In the Drawings

Please replace Figures 4 and 5A-5D with the corrected drawings sheets attached hereto.

Remarks

FIGURE 4

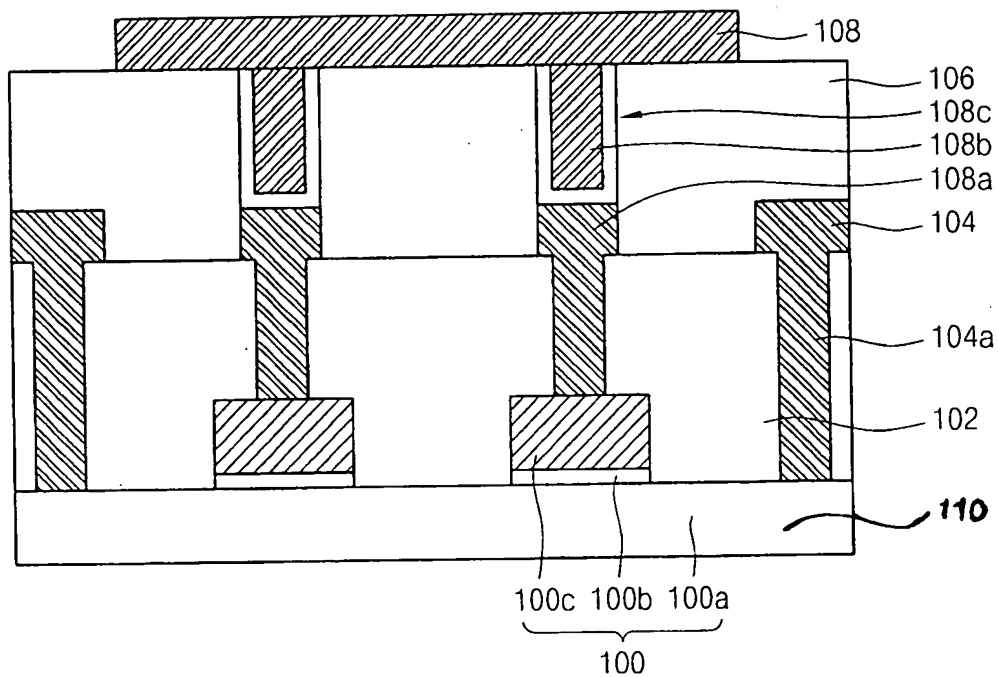
The drawings are objected to at pages 2-3 of the latest Office Action. Submitted herewith are corrected drawing sheets in compliance with 37 CFR 1.121(d). Figures 4, 5A-5D have been amended to show a “semiconductor substrate”. The specification has been correspondingly amended to include a reference number for the “semiconductor substrate”. Applicant asserts no new matter has been added by these amendments.
